ULPOWER AERO ENGINES N.V.

DATE: September 24, 2010 Service Bulletin No. 2010-01

SUBJECT: Propeller flange bolt locking

MODELS AFFECTED: UL260i / UL260iS

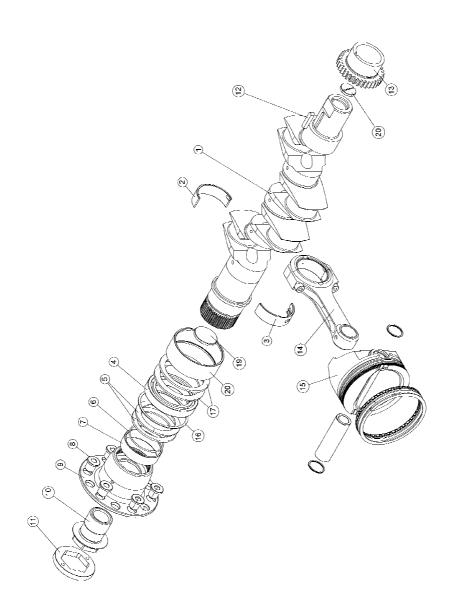
ULPower has determined that the 'Nord lock washer' used to lock the propeller flange bolt is not reliable. Because of this, ULPower changed the way of locking. Instead of the Nord lock washer, ULPower now uses a hexagonal locking washer (part no. 11, see fig. 1).

ULPower already changed this since serial no. 090000, and because of some tests, also a few engines with serial no. lower than 090000 have already been modified.

- Order part 11 (see figure 1), ref. No. E022510B. And the necessary special tools.
- Remove the propeller
- Tighter the bolt no. 10 clockwise to 300 Nm. Use the special tool to hold the propeller flange
- Slide the washer (E022510B) over the hexagonal part of the propeller flange bolt (see figure 2)
- Drill a hole dia 5 through the propeller flange and in the middle of the hexagonal locking washer (see figure 2)
- Cut M6 threat till the bottom of the hole (figure 2)
- Use a hexagon socket screw M6x15 and fix it with Loctite 243
- Lock the screw again by punching 2 dimples (see picture 2)
- Replace the propeller
